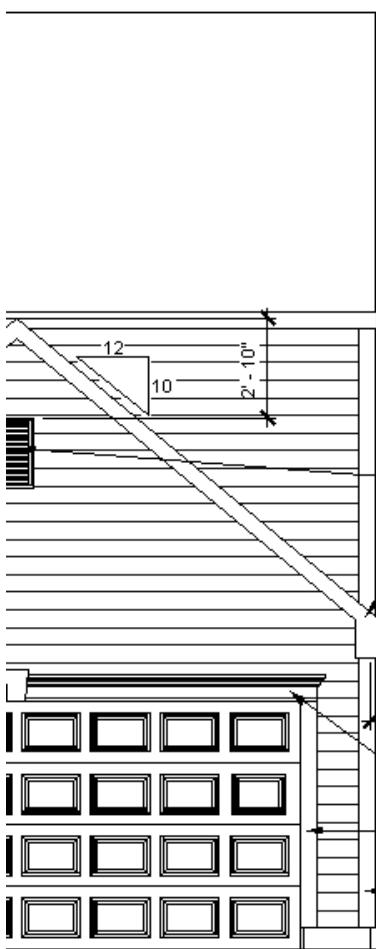
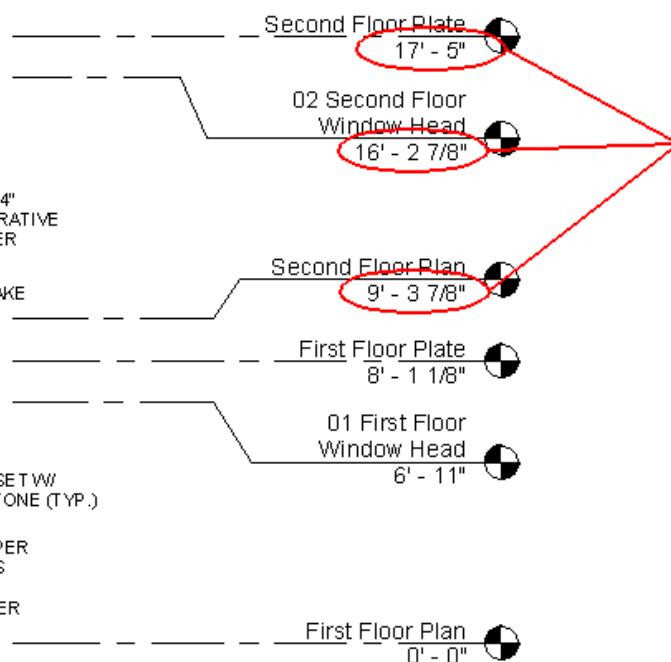
This information is useless. Builder needs to reference these heights relative to a 0'-0" starting point at the Second Floor Plan level.

Building from the ground up, once the 2nd floor has been constructed 2nd floor window and plate heights are dimensioned from a 0'-0" 2nd floor reference. This is how I need the 2nd floor level heads to display in elevation views.
